Donegal Cliffs Park Rehabilitation

Addendum #1

May 7, 2015

Donegal CliffsPark Rehabilitation
Concrete Curb Detail

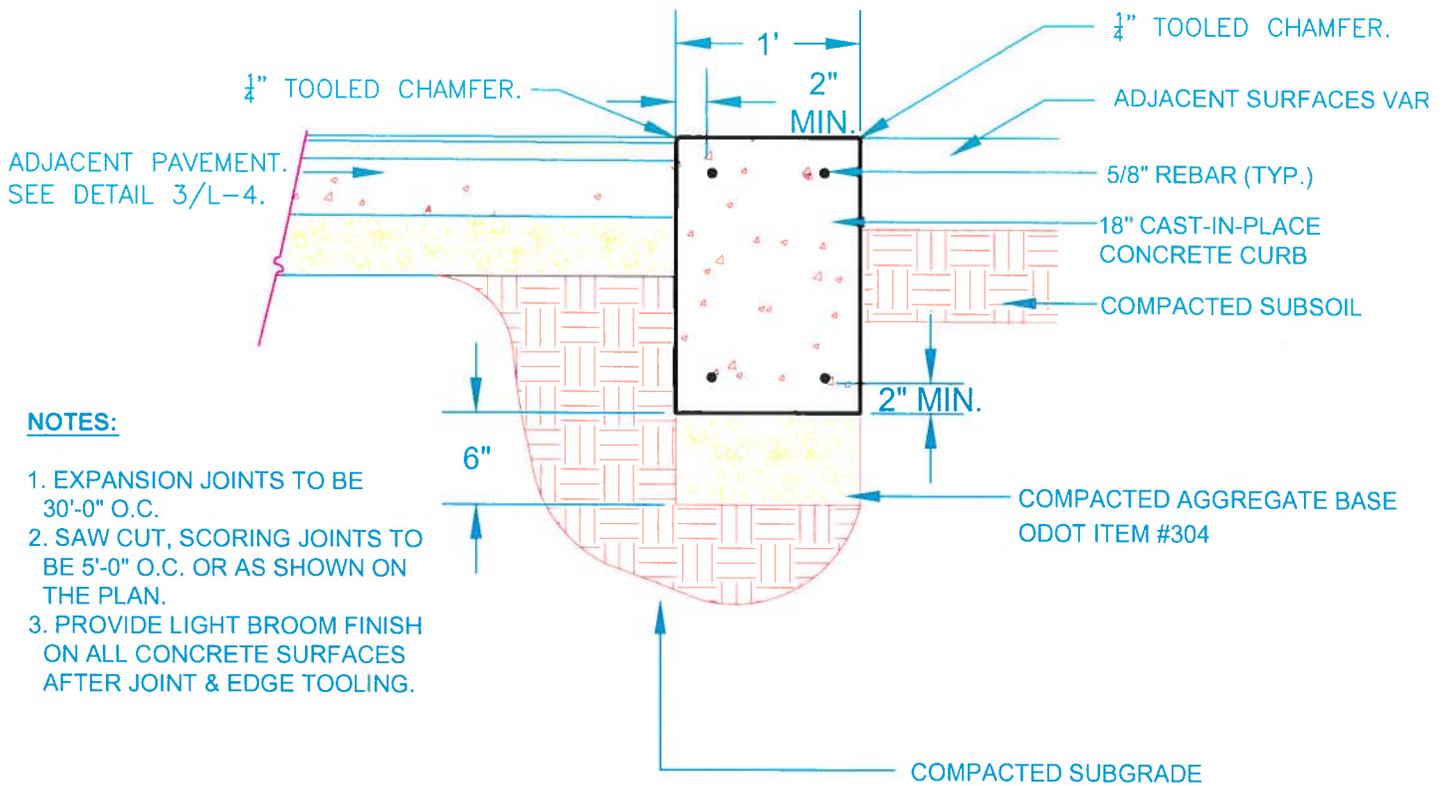
Item #2: Unit pricing for 1' concrete curb to match the existing playground curb is being added to the project Proposal form for consideration in areas around the basketball court. The detail is being issued under this cover. The project Proposal form is being reissued to incorporate unit pricing.
